PLUMBING NEWSLETTER

All information herein was referenced for the Winston-Salem/Forsyth County Area. If you have questions concerning other Inspection Divisions, please contact that division for your answers.

QUESTIONS FROM CONTRACTORS.

PROPERTY SIDE CONNECTION TO CITY MAINTAINED HDPE CLEANOUT STACK

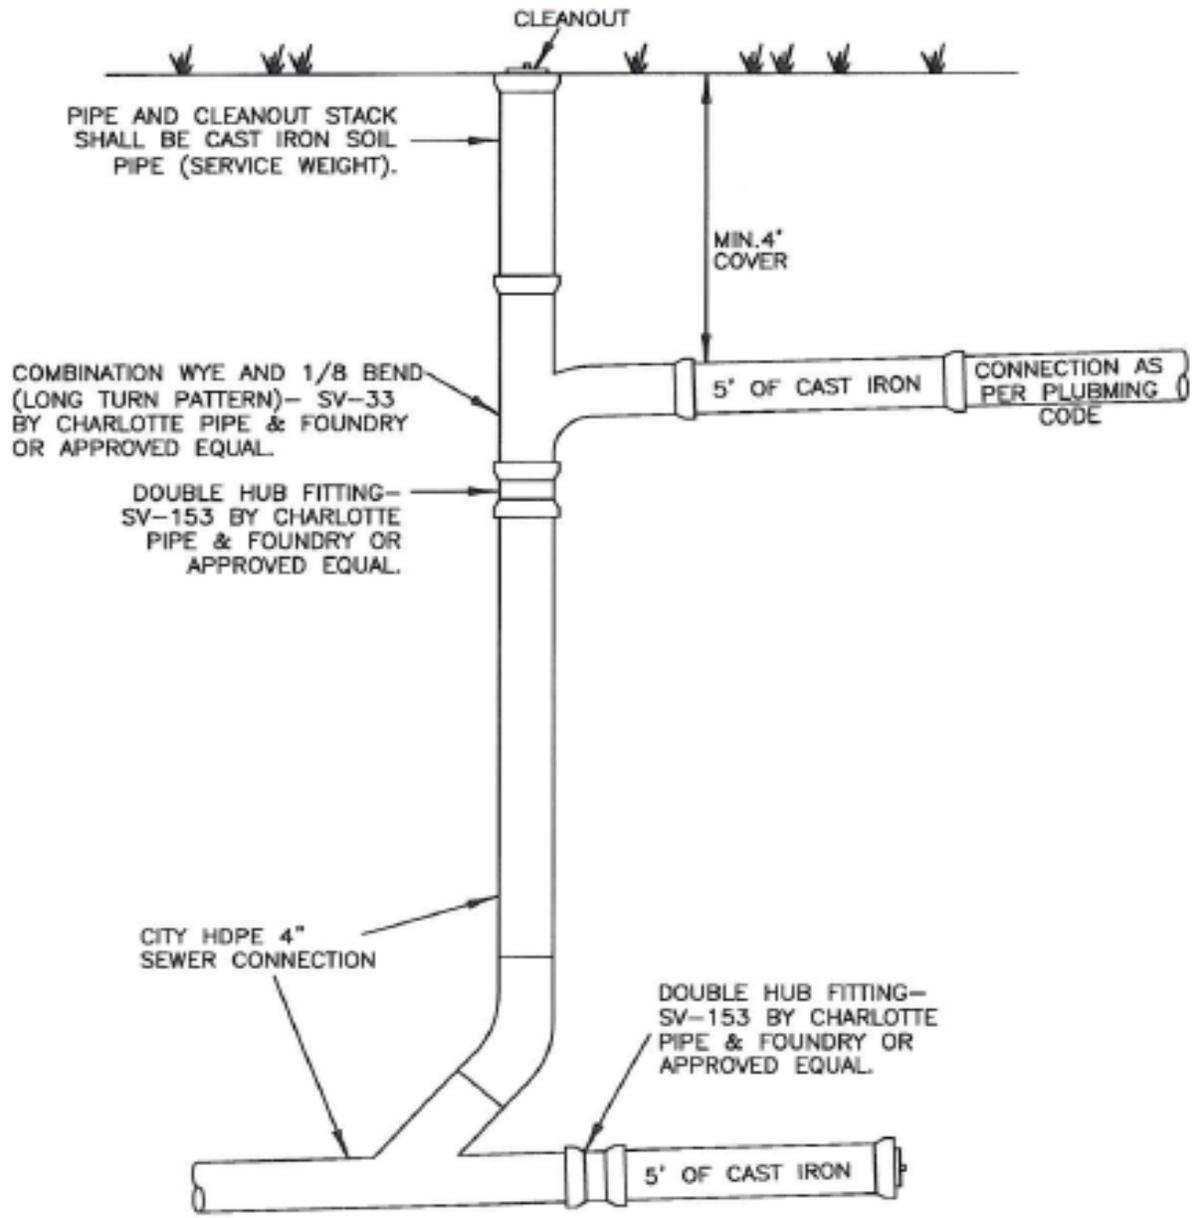
Q: Does the Winston-Salem City Utilities have a new sewer stack tie-in diagram for the HDPE pipe being installed on these rehab sewer installations?

A: Yes, on page 2 and 3 you will find a copy of the requirements that Winston-Salem City Utilities will allow for a connection to each type of their sewer stacks.

NOTE: THIS DETAIL SHALL BE USED FOR REHABILITATION PROJECTS WHERE THE SEWER CLEANOUT STACK IS HDPE MATERIAL. JOINTS SHALL BE HUB WITH RUBBER GASKET. NO-HUB COUPLINGS SHALL NOT BE USED.
